File: \\projects\mcc\20000\04-Production\As-Built\DWG\WBC20000-Add-15-WATER.dwg
 Plot: 10/27/2023 2:54 PM, by Matthew St. Marie, 10/27/2023 2:40 PM, by srm
 1411 Block A
 SWBC Rockwall
 Addition, Phase 1
 2019-4592

AS-BUILT RECORD DRAWING

C4.08

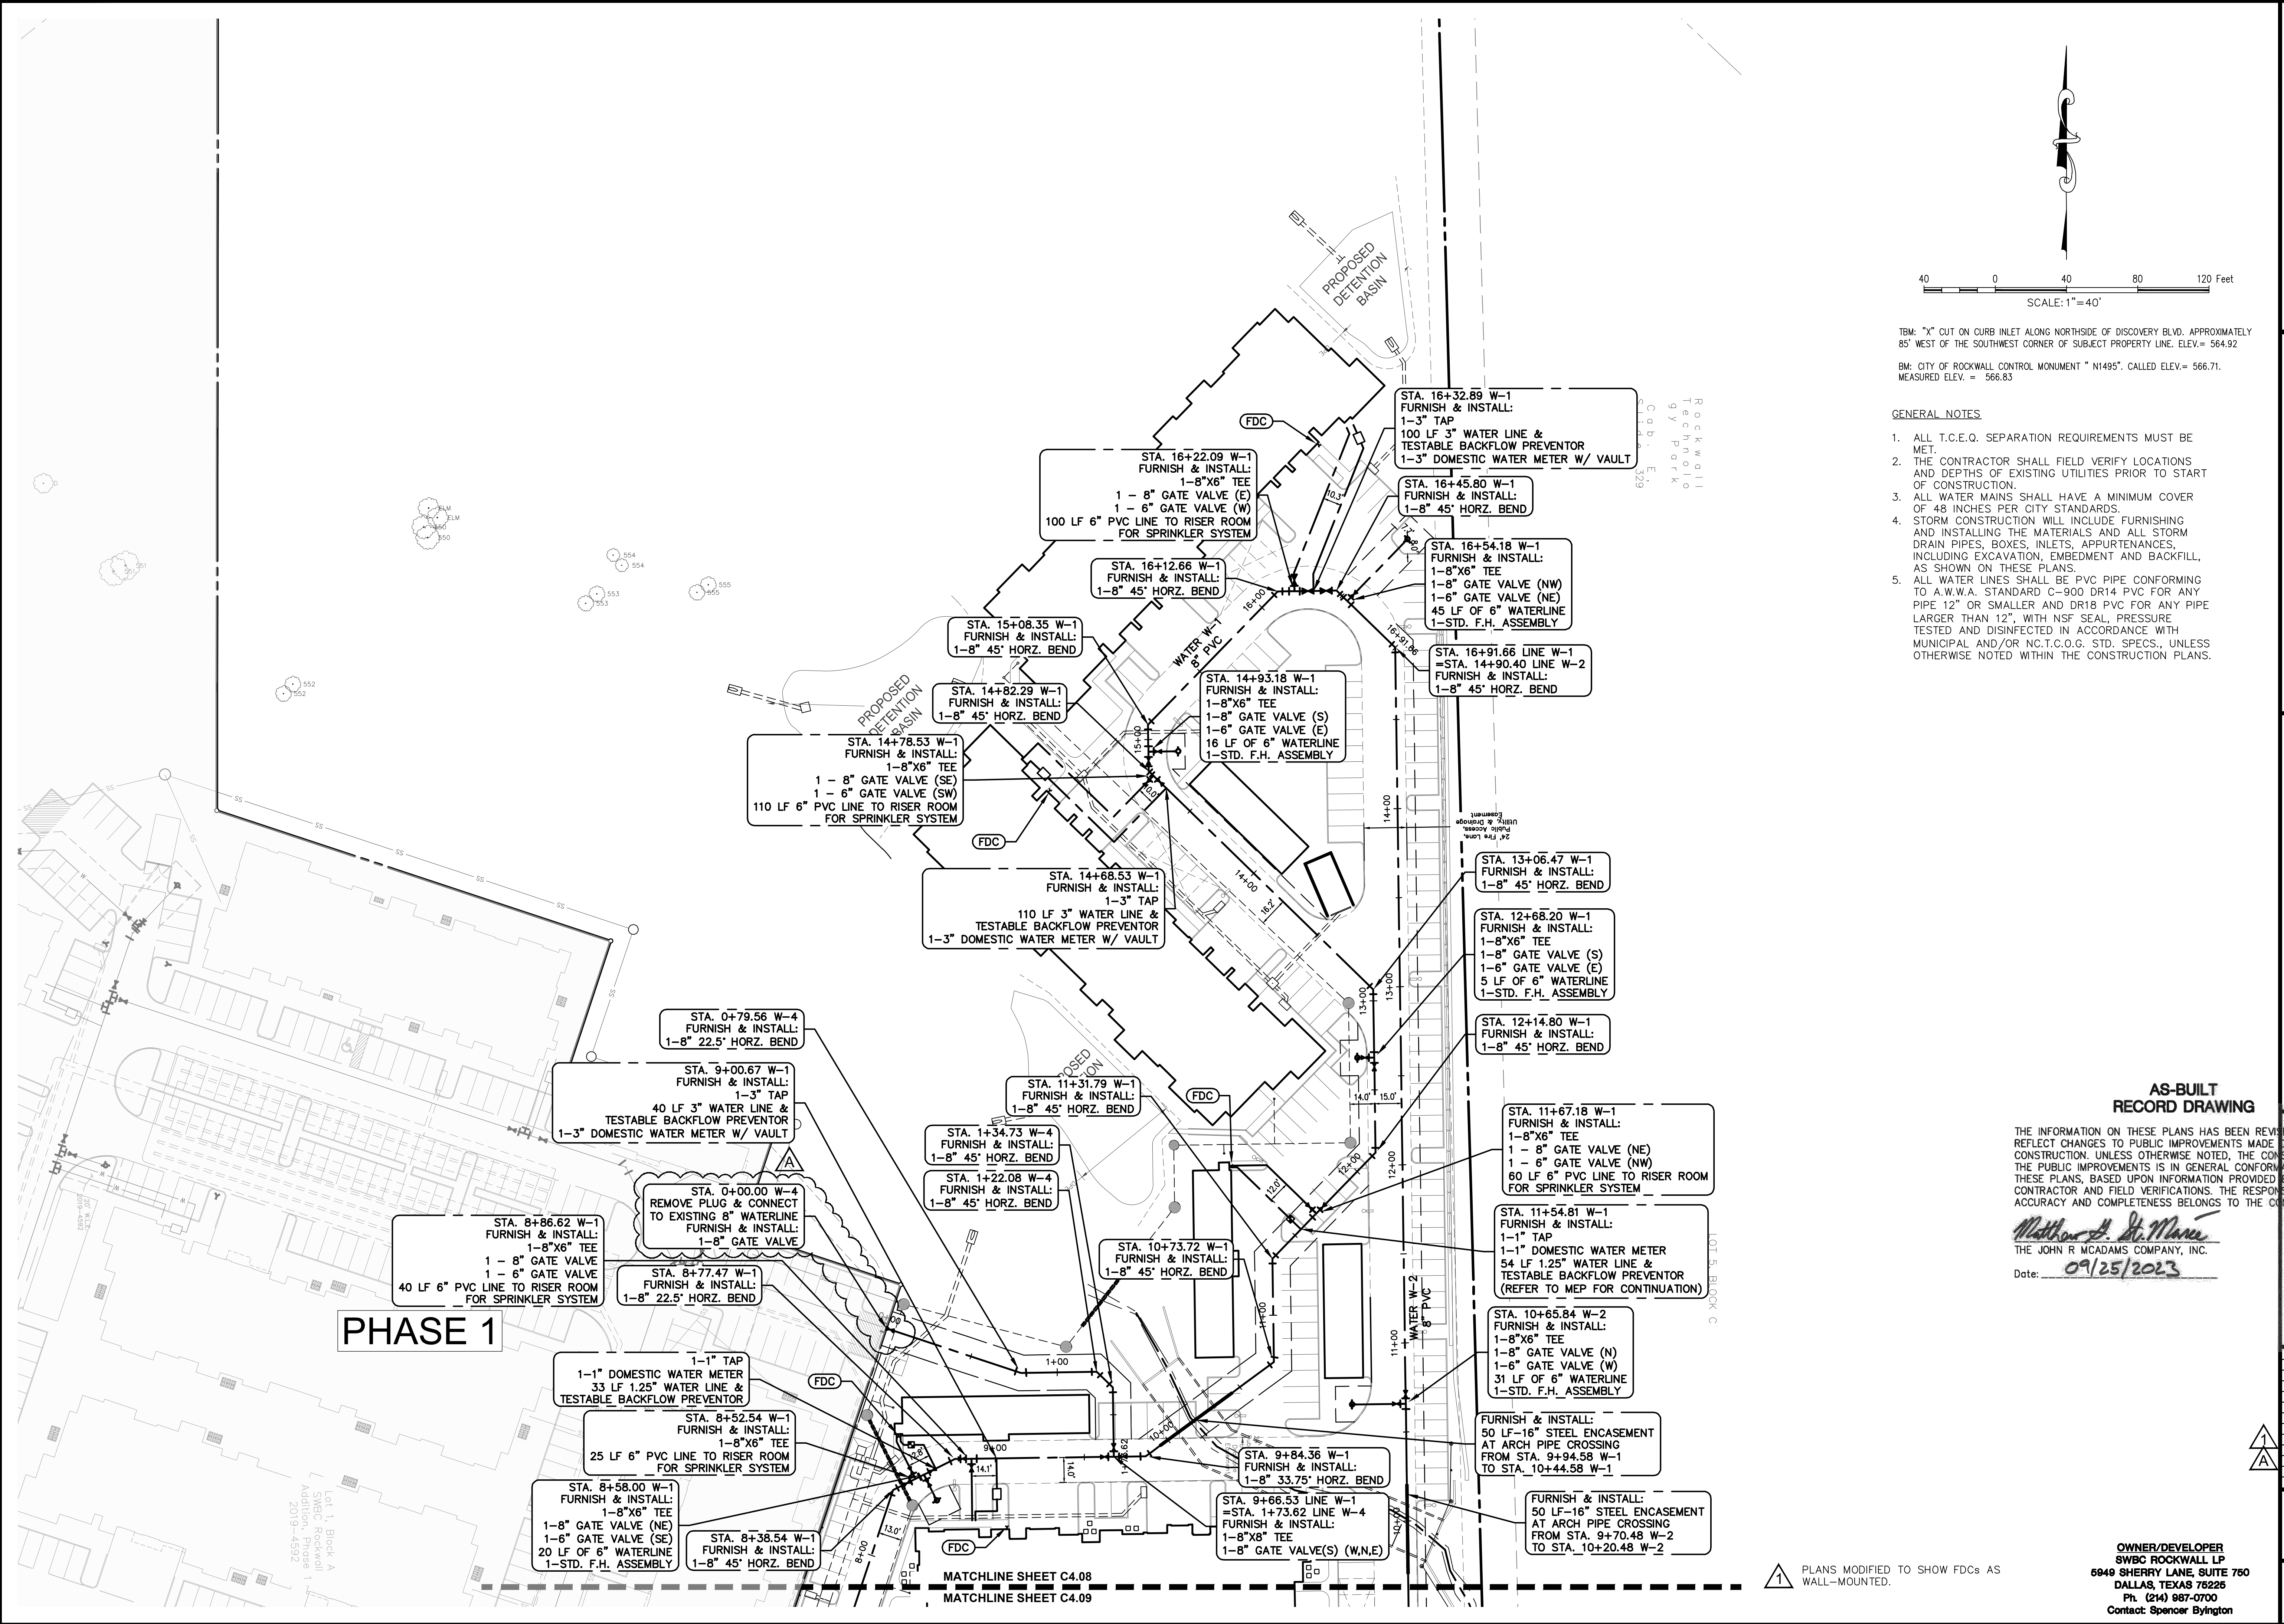
PLANS MODIFIED TO SHOW FDCs AS WALL-MOUNTED.
